Amendments to the Drawings:

REMARKS/ARGUMENTS

Thelen Reid & Priest – Robert E. Krebs
Serial No.: 10/045,199
Filing Date: October 22, 2001
TRP Docket No.: 034942-255

Fig. 6

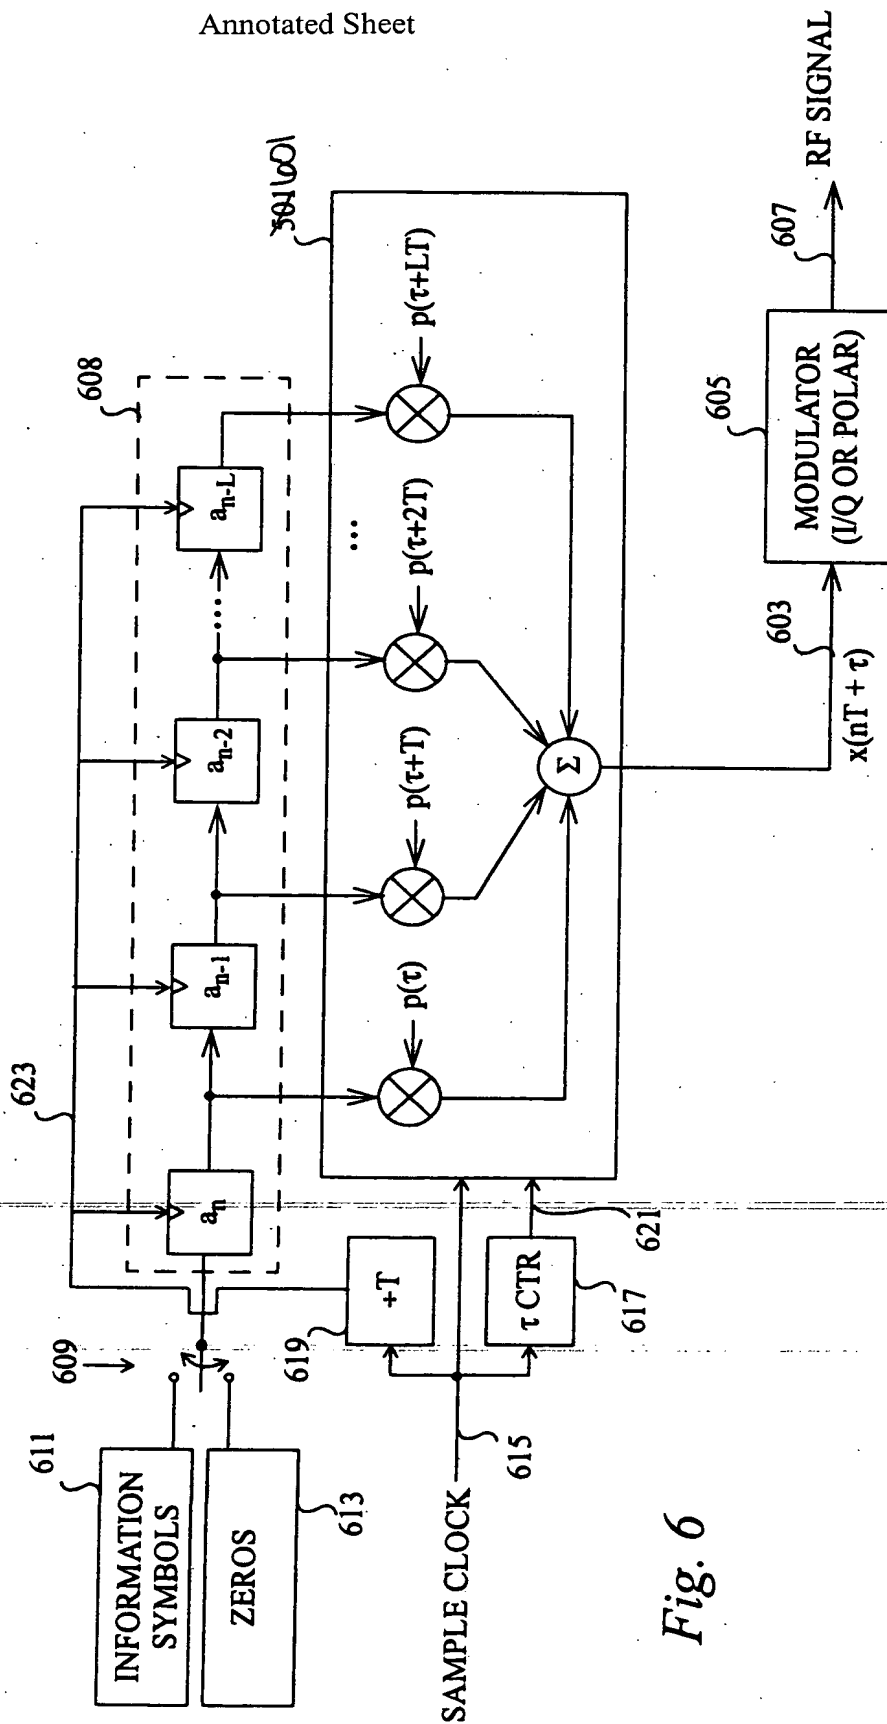
FIG. 6 has been amended to amend number “501” to “601”
